# NOTICE OF DECISION

## PLANNING ADMINISTRATOR DECISION FOR SITE PLAN REVIEW

**CASE TYPE:** Class 2 Site Plan Review  
**AMANDA NO.:** 21-115171-RP  
**DATE OF DECISION:** January 3, 2022  
**PROPERTY LOCATION:** 3514 Commercial St SE  
**APPLICANT:** Kevin Godwin for JJS Holdings, LLC  
**ZONE:** CR (Retail Commercial)  
**COMPREHENSIVE PLAN:** Commercial  
**OVERLAY:** None

A Class 2 site plan review for a change of use from retail sales/vehicles services to solely retail sales with associated site upgrades including landscaping, new parking lot layout, and pedestrian connections for an existing building at 3514 Commercial St SE (Marion County Assessor Map and Tax Lot 083W03DB / 7300).

2 PROPOSED LANDSCAPE | EXISTING SURVEY

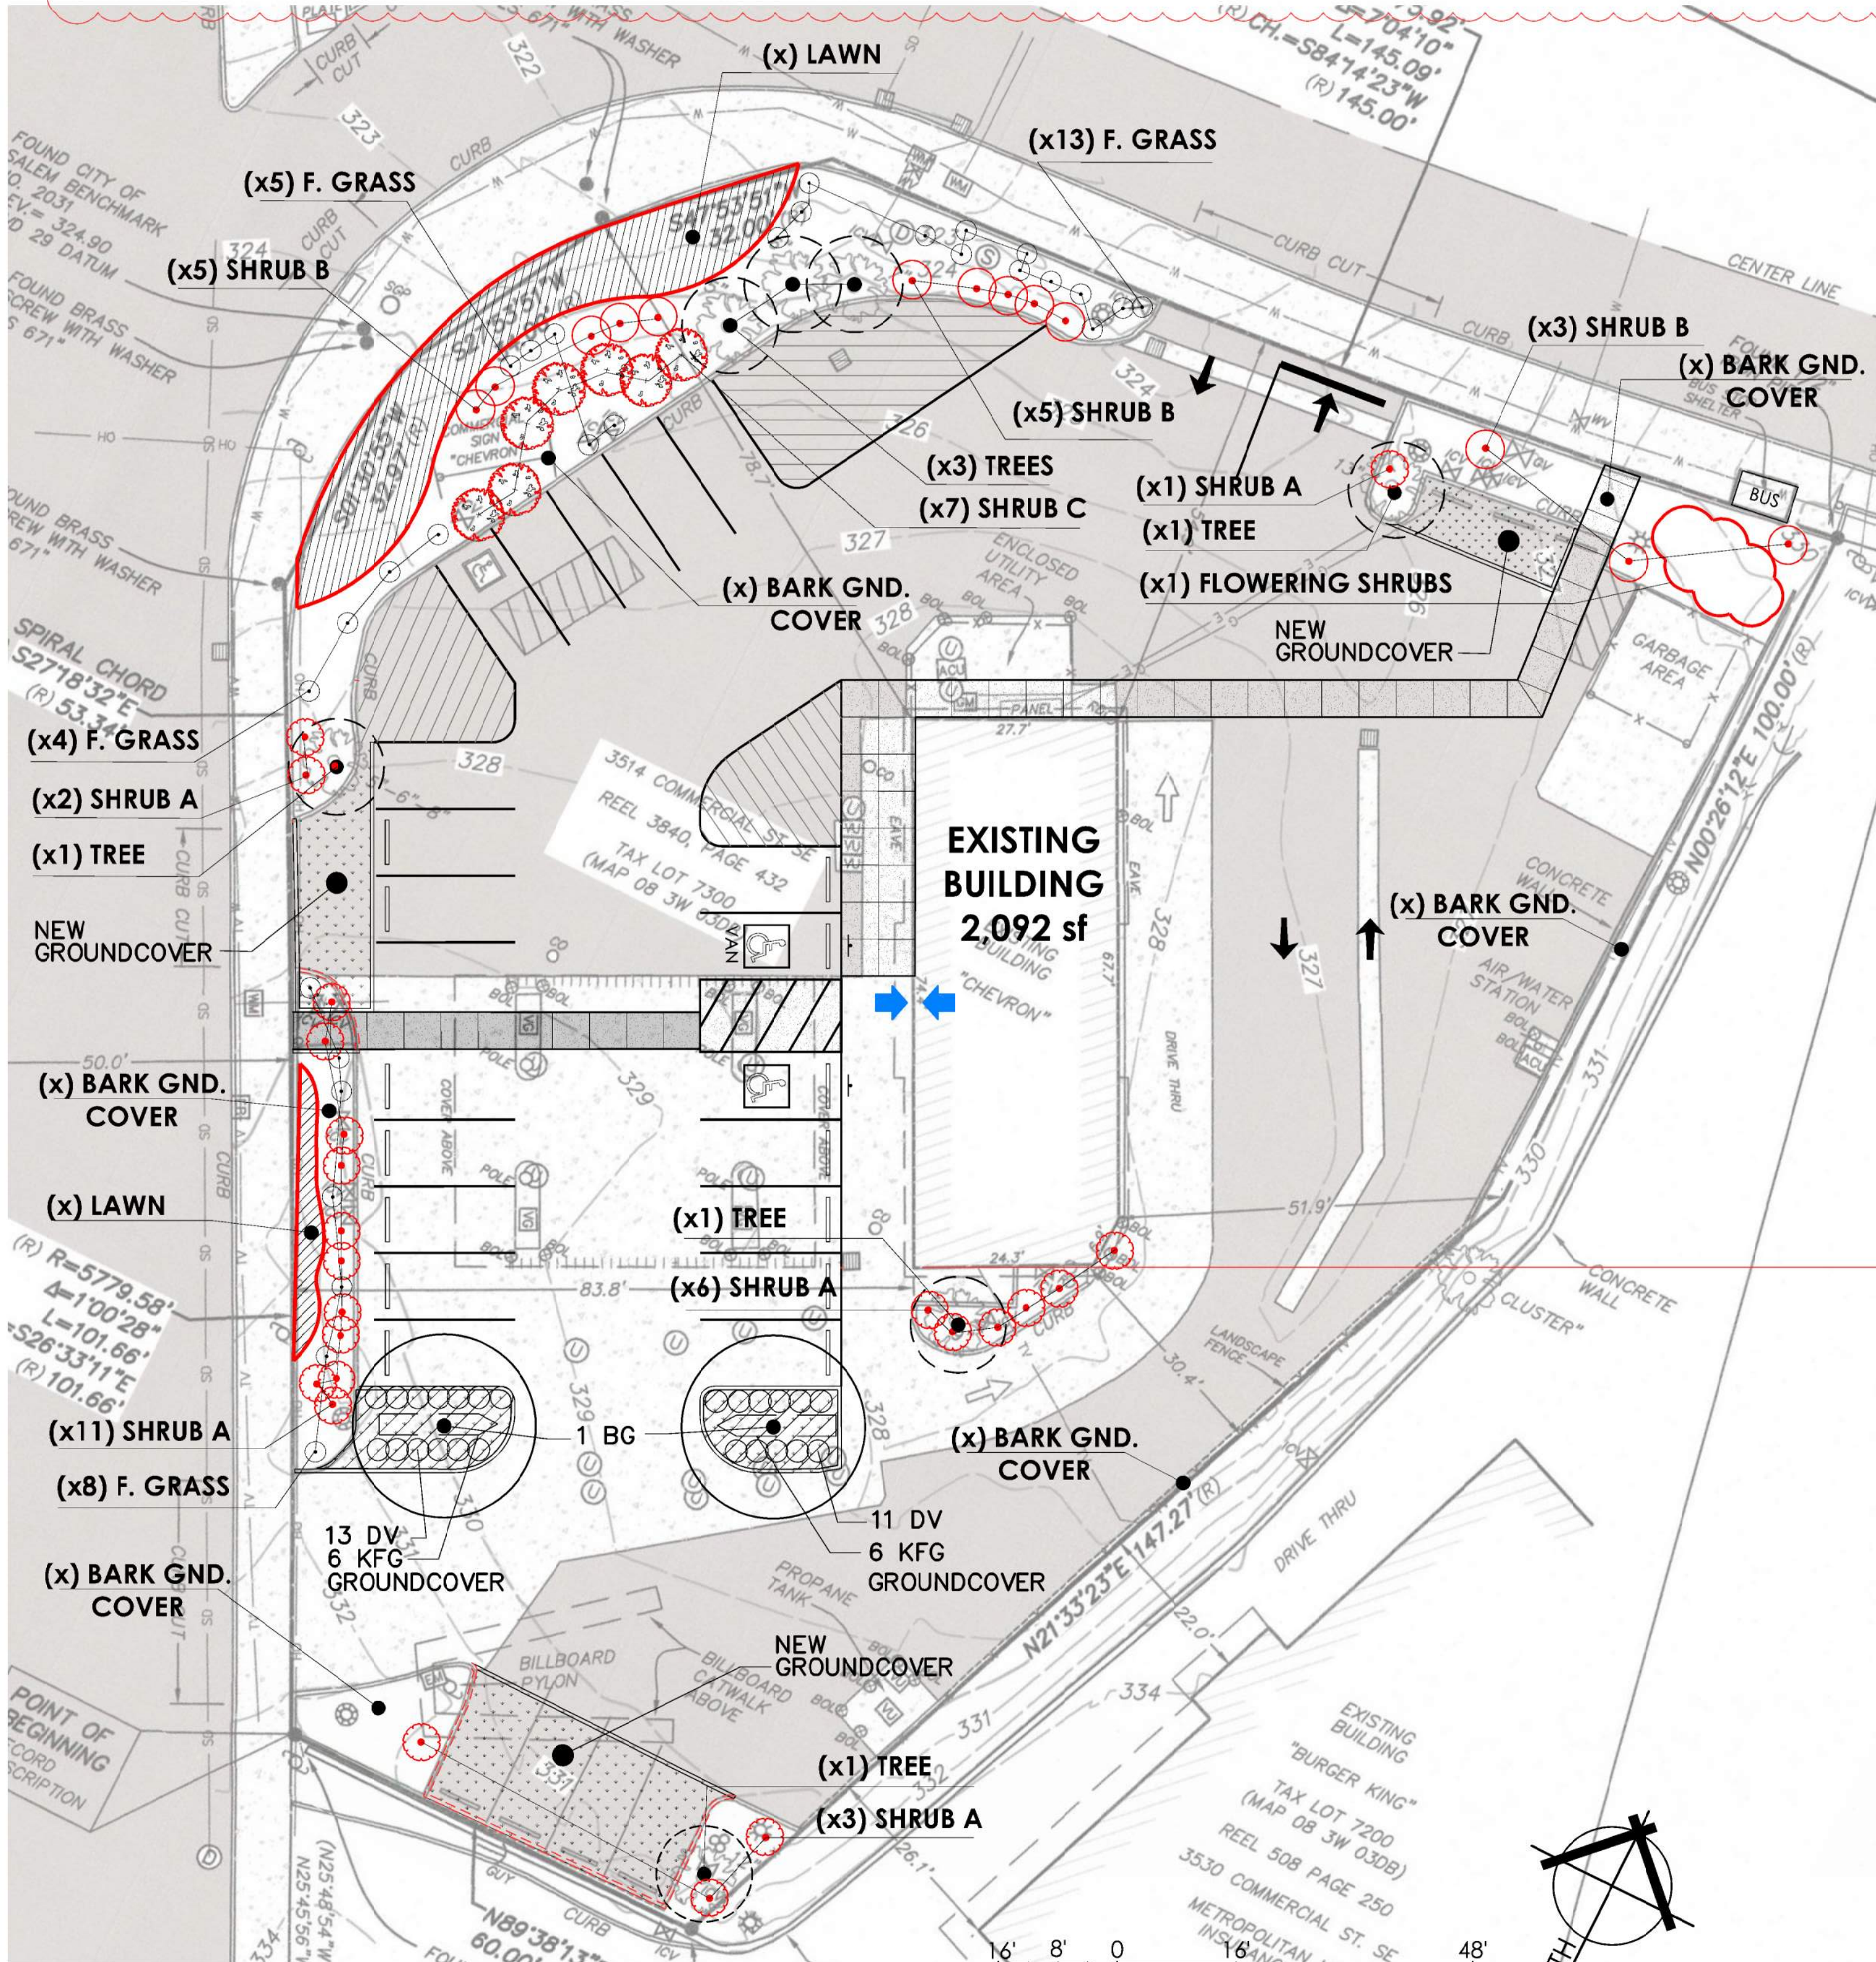
**Finding:** The applicant has provided a tentative landscaping plan which meets the minimum landscaping standards of the zone. Full compliance with this standard will be reviewed at building permit.

**Finding:** A minimum of 1 plant unit is required per 20 square feet of landscape area. A minimum of 40 percent of the required plant units shall be a combination of mature trees, shade trees, evergreen/conifer trees, or ornamental trees. Landscape and irrigation plans will be reviewed for conformance with the requirements of SRC 807 at the time of building permit application review.
